**PLANNING AND ZONING AND COUNTY COUNCIL INFORMATION SHEET**  
Planning Commission Public Hearing Date April 8<sup>th</sup>, 2021.

Application: (2019-29) Scenic Manor (F.K.A. Estates at Mulberry Knoll)

Proposed Use: Residential – 319 Single Family Lots as a Cluster Subdivision.

**SUSSEX COUNTY ENGINEERING DEPARTMENT  
UTILITY PLANNING & DESIGN REVIEW DIVISION  
C/U & C/Z COMMENTS**

DATE	REVISIONS	JOB NO.:
12/18/20	UPDATED WETLANDS AND LOT CONFIGURATION	20572
03/25/21	REV. LOT CONFIGURATION TO ELIMINATE BUFFER OVERLAP	SCALE: 1"= 50'
		DATE: 12/02/19
		DRAWN BY: CJF
		DESIGN BY: CJF
		REVIEW BY: PLT
		SHEET: 10 OF 15

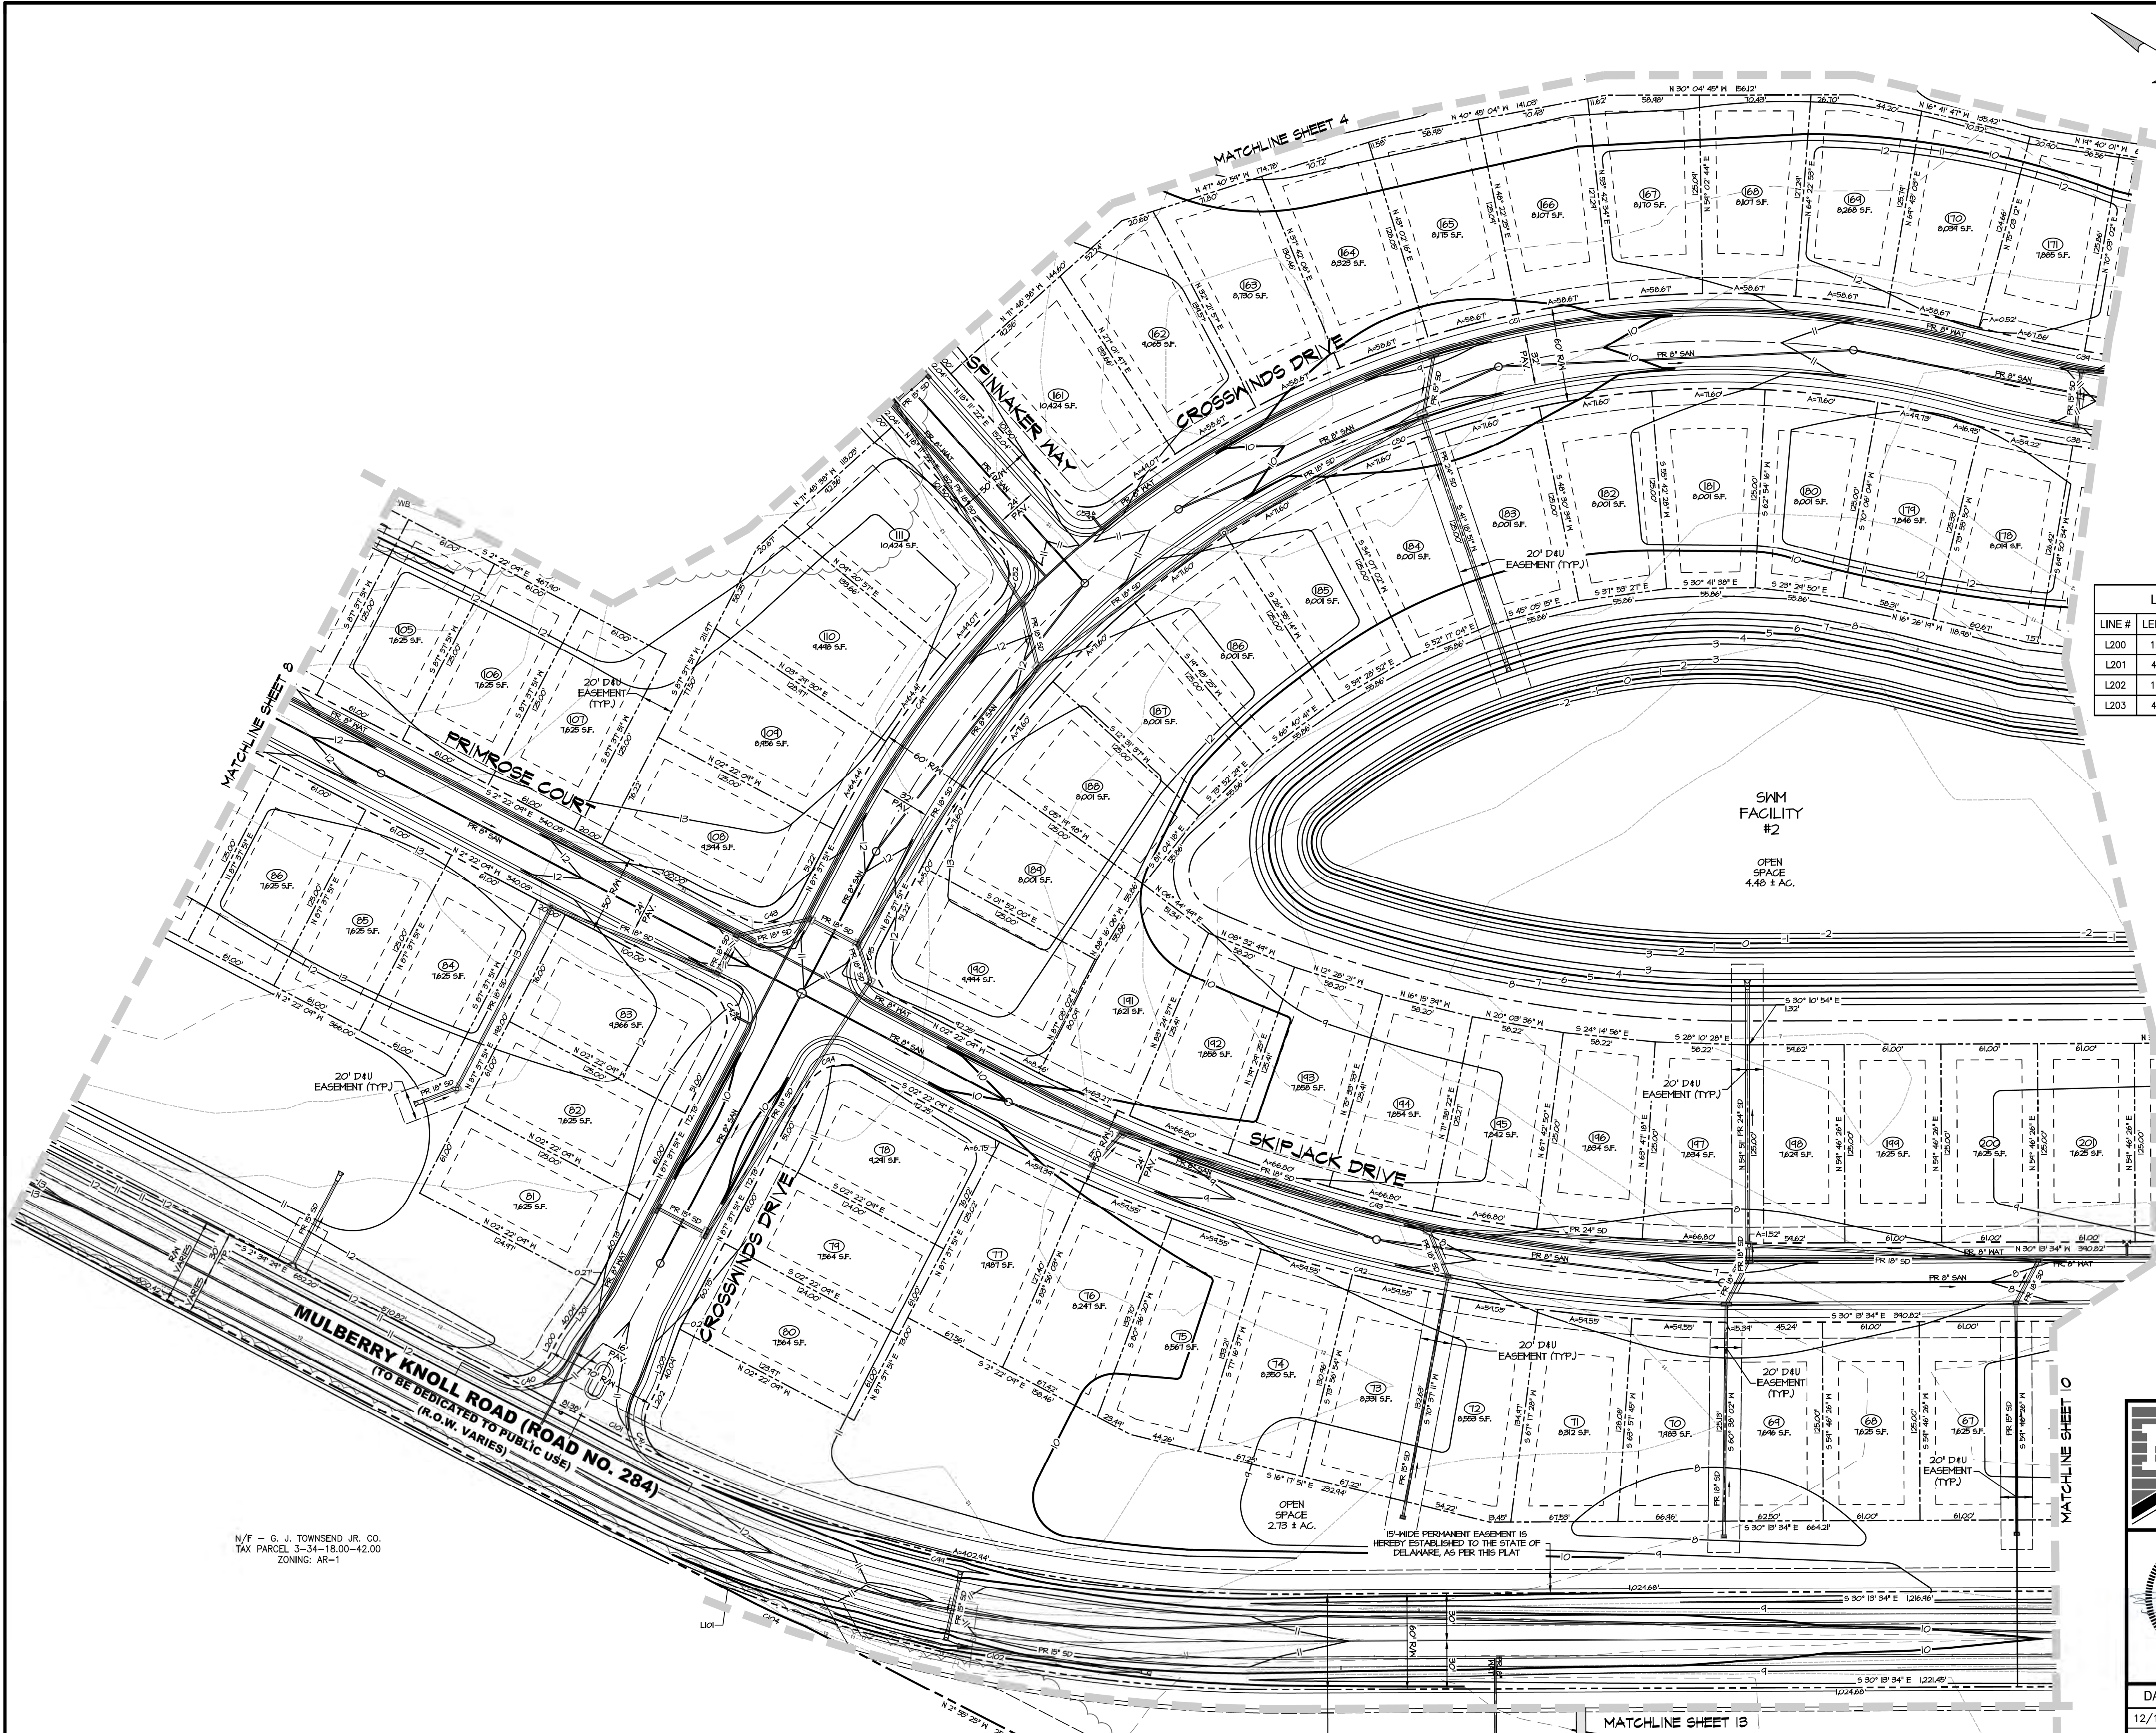
Comment 7: As necessary, in accordance with Section 3.2.5 and Figure 3.2.5-aof the Manual, DelDOT will require dedication of right-of-way along the site's frontage on Mulberry Knoll Road. By this regulation, this dedication is to provide a minimum of 30 feet of right-of-way from the physical centerline. The following right-of-way dedication note is required, "An X-foot wide right-of-way is hereby dedicated to the State of Delaware, as per this plat."

ADDITIONAL 4.71 AC. ± RIGHT-OF-WAY IS HEREBY DEDICATED TO THE STATE OF DELAWARE, AS PER THIS PLAT (WIDTH VARIES)
